International Code Council

**ICC 500-2020 edition
Public Input Agenda with
Committee Votes and Public Comments
based on input received
on 2014 edition of the
ICC 500 Standard**

**For February, 2020
2nd Meeting – Teleconference**

2014 ICC 500-Standard Revision Proposals – Public Comments

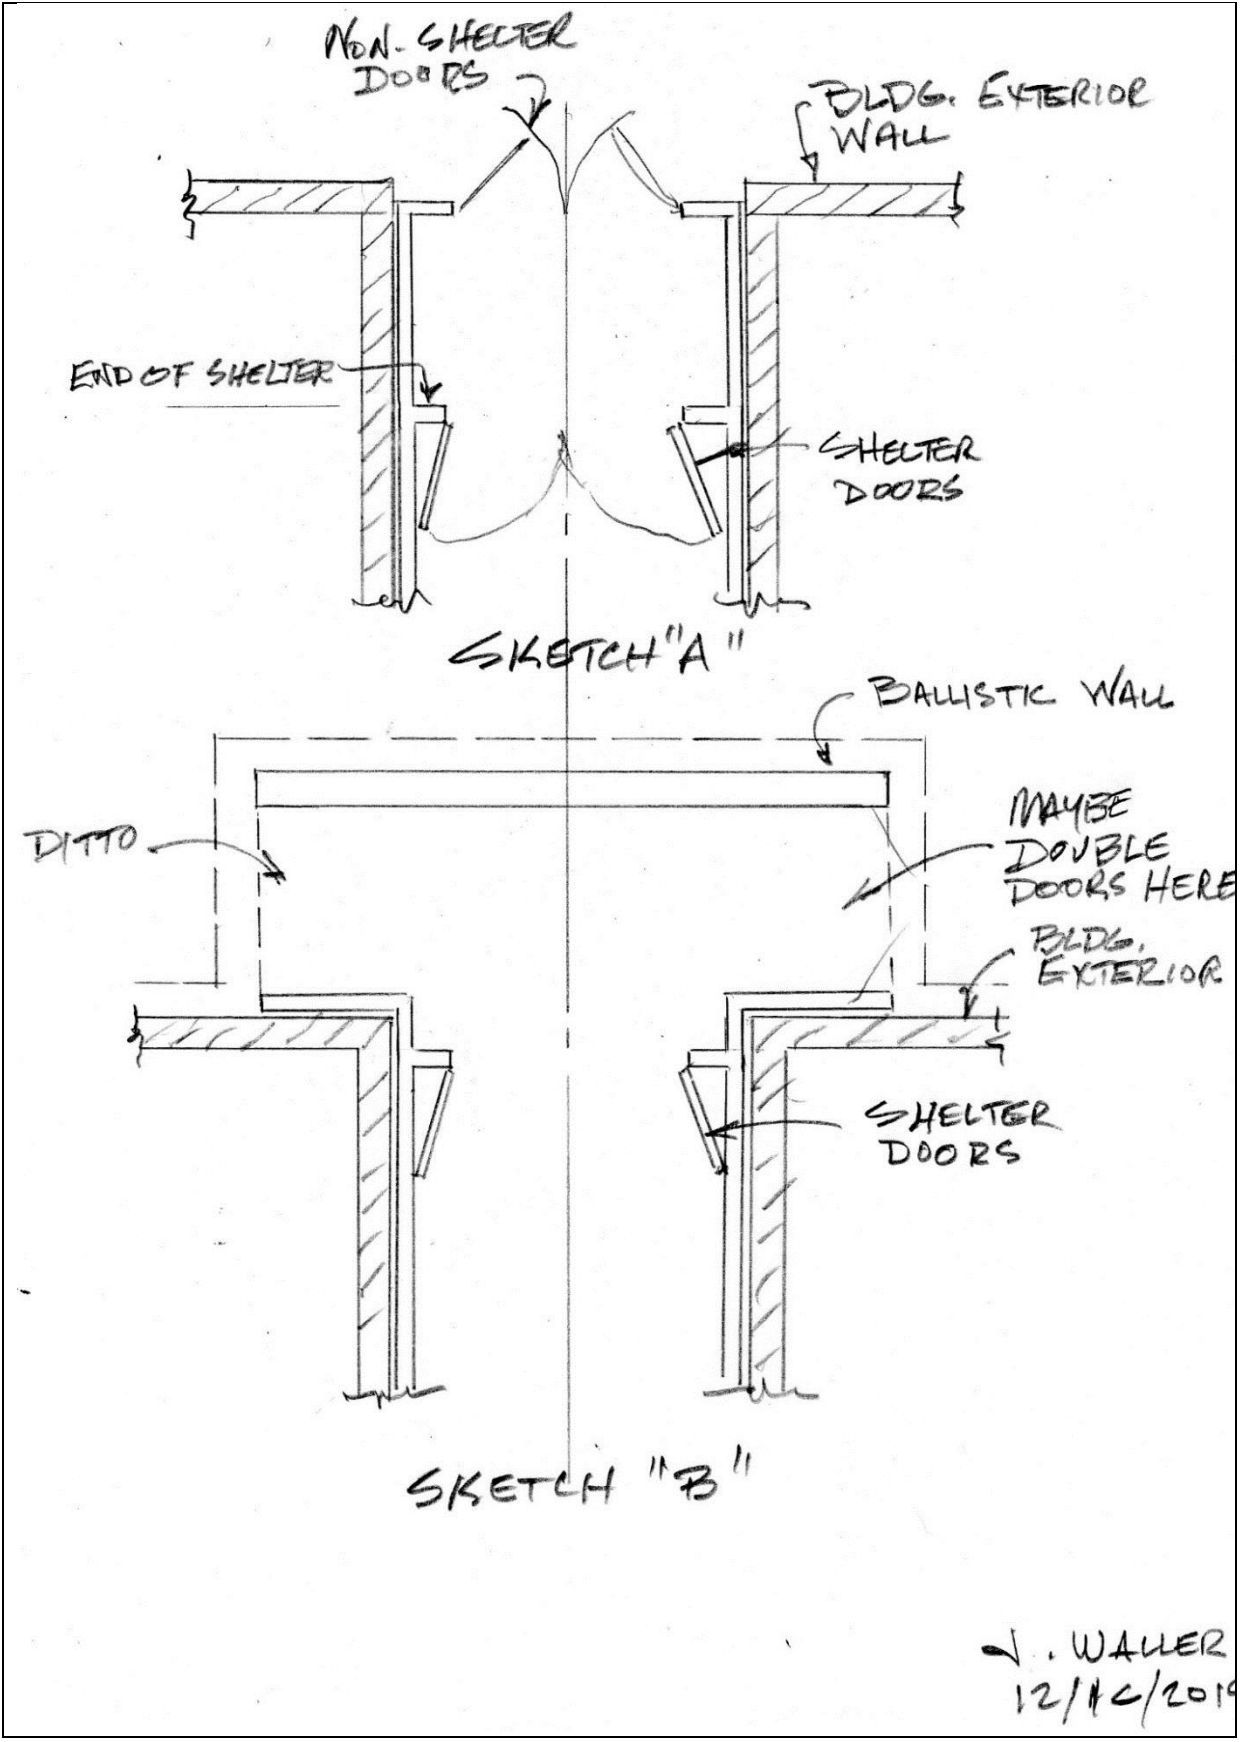
events; the non-shelter doors are used at all other times. The egress would be similar to a baffled entry in that the protected shelter envelope would extend to the exterior wall.

- b) The corridor of a storm shelter exits directly to the exterior of the building as shown in Sketch B. A ballistic wall protects the corridor. If the shelter walls and roof extend over the ballistically-protected alcove as shown in Sketch B, and the ballistic wall is part of the storm shelter, does the shelter meet Exception 4?

- c) For Sketch B, if non-shelter egress doors are installed at the two ends of the alcove, does the shelter meet Exception 4?
2. Public storm shelters constructed within a host building may have dual uses which involve regular paths of egress requiring entry doors for security and protection from weather, dust, wind, etc. The heavy storm doors would be recessed from the entry doors and held in an open position except when required to be closed for storm activity. The entryway between the entry doors and the storm doors would be dedicated path of egress and would be of sufficient length to protect the steel storm doors from weather during normal use of the building.

FIGURE 804.9.6(1) ~~SHUTTERS OR~~ OTHER IMPACT PROTECTION SYSTEMS

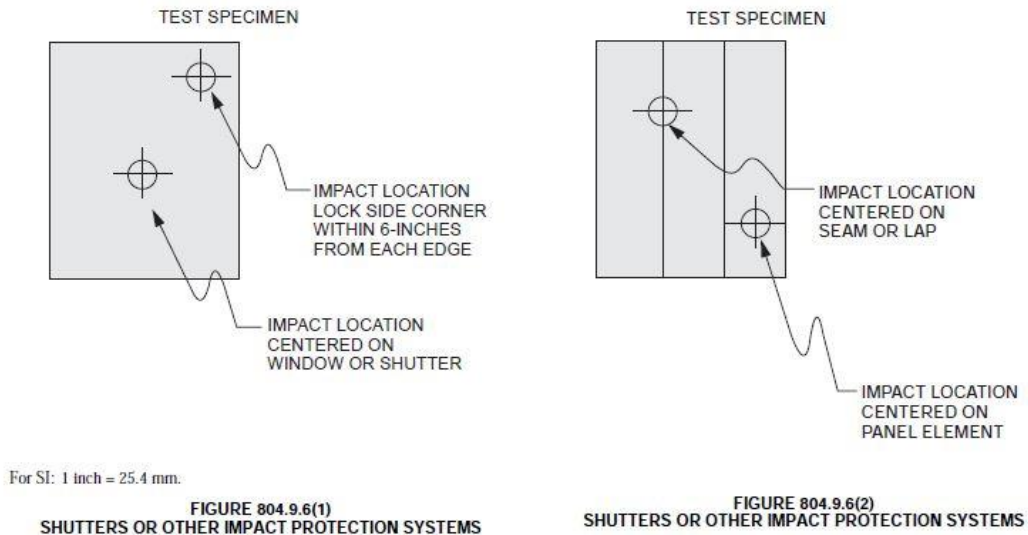
804.9.6 Other Impact-protective systems. All ~~shutter assemblies and~~ other *impact-protective systems* shall be impacted in the center of the closed opening, and at one interface corner as detailed in Figure 804.9.6(1). Panels and interface joints shall be impacted as shown in Figure 804.9.6(2). Interface hinge joints and primary latches, where present, shall be impacted as shown in Figure 804.9.5(2) on an additional specimen. All ~~shutter assemblies and~~ impact protection systems that include swinging door assemblies with latching hardware shall be tested in accordance with Section 804.9.5.

FIGURE 804.9.5(3)
ROLLING DOOR ASSEMBLIES

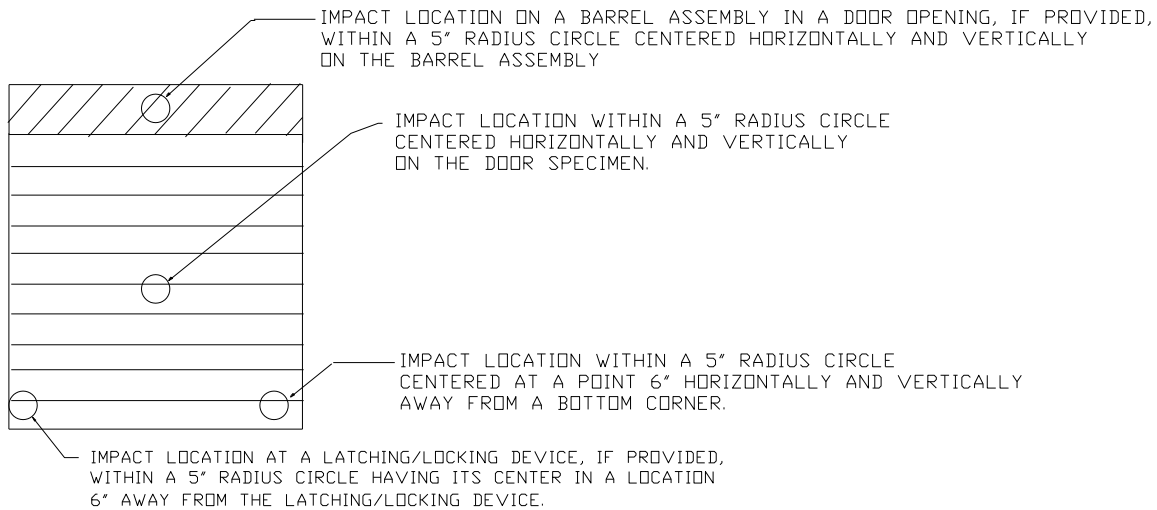
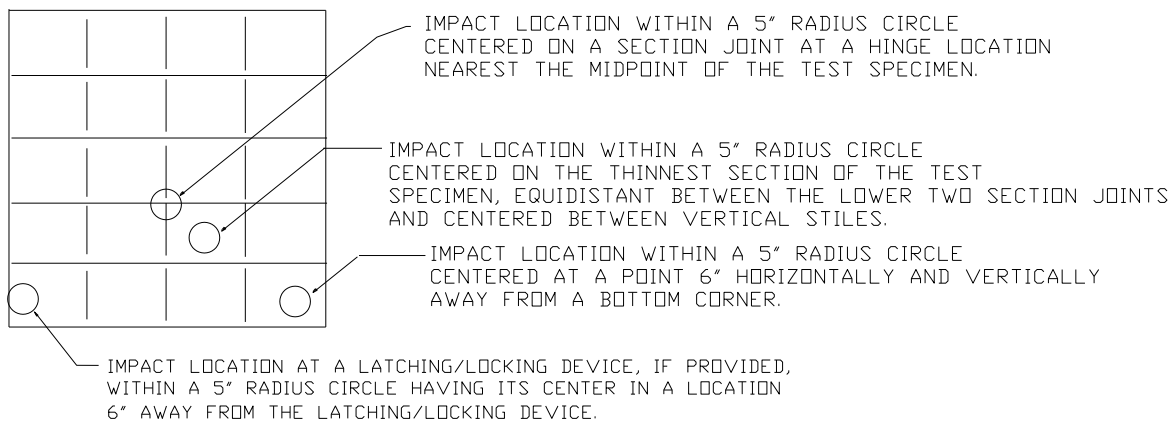
For rolling door assemblies, the door shall receive two impacts as shown in Figure 804.9.5(3) plus an additional impact on a latching/locking device if provided, plus an additional impact on a barrel assembly if mounted in the door opening.

For sectional door assemblies, the door shall receive three impacts as shown in Figure 804.9.5(4) plus an additional impact on a latching/locking device if provided.

Reason: Clarify application of door impact provisions with respect to testing of rolling and sectional doors

FIGURE 804.9.5.2
ROLLING DOOR ASSEMBLIES

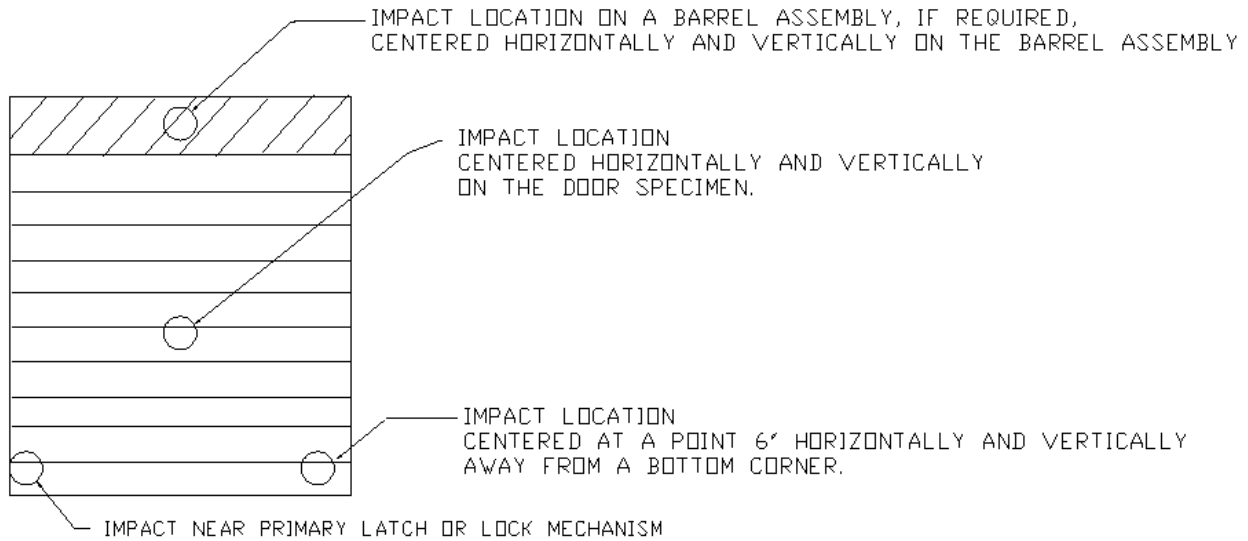
804.9.5.2 Rolling door assemblies. For rolling door assemblies, the door shall be impacted at the center of the door, at one bottom corner and within 6 inches (152.4 mm) of primary latches or operators, plus an additional impact centered on a barrel assembly as shown in Figure 804.9.5.2.

Exception: The barrel assembly is not subject to the additional impact where the entire barrel assembly is protected by the shelter envelope.

FIGURE 804.9.5.3
SECTIONAL DOOR ASSEMBLIES

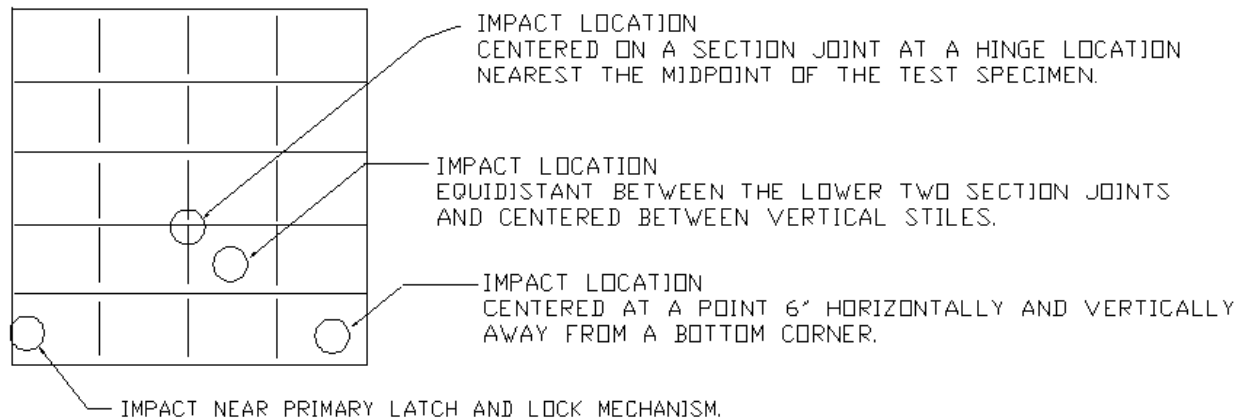
804.9.5.3 Sectional door assemblies. For sectional door assemblies, the door shall be impacted at a sectional joint nearing to the center of the door, within the lower two section joints and centered between two vertical stiles, at one bottom corner, and within 6 inches (152 mm) of the primary latches or operators as shown in Figure 804.9.5.3.

**FIGURE 804.9.7.2
DOORS SUBJECT TO REBOUND IMPACT**

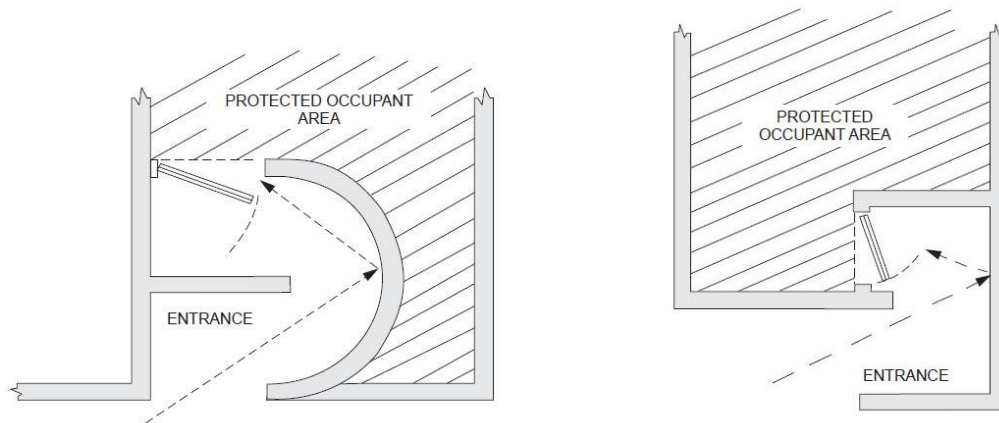
804.9.7.2 Door subject to rebound impact. Where the alcove or baffled entry system prevents a first impact of the design missile on the door but the door is subject to a rebounded impact of the design missile after it has impacted one surface meeting the requirements of Section 306.2 possible (~~see [as detailed in](#) Figure 804.9.7.2~~), then a door assembly shall meet the wind load requirements of Section 304 and the debris impact requirements of Section 305 except that the missile shall be, at a minimum, a 9-pound sawn lumber 2 by 4 traveling at 50 feet per second (15.2 m/s). Entry systems having doors that are protected from the initial and first rebounded impacts of debris shall comply with the requirements of Section 804.9.7.1.

Reason: The way figures are referenced is not consistent and does not make the figure part of the requirement. Using “as detailed in” or “as shown in” would be consistent with the figure references of impact location in 804.9. In Items 1, 2 and 3 of Section 804.9.7, “Examples of this type of system are shown in Figure...” is not needed. As written it is editorials information, not a requirement; and the figures are referenced in each of the referenced sections.

FIGURE 804.9.7.3
DOORS SUBJECT TO FIRST IMPACT

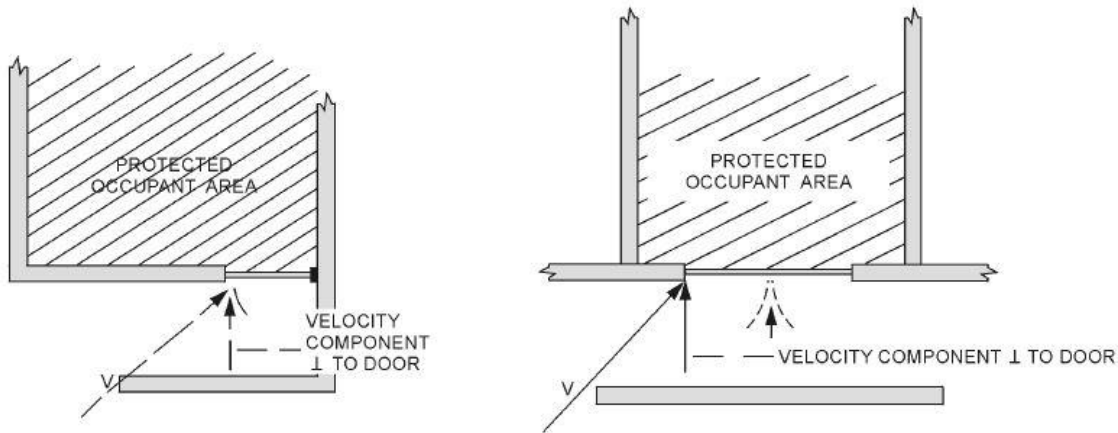
804.9.7.3 Door subject to first impact. If a first-strike angle missile impact on the door is possible (~~see as detailed in~~ [Figure 804.9.7.3](#)), then the door is deemed suitable if the door assembly meets the wind load requirements of Section 304 and the door assembly meets one of the following debris impact criteria:
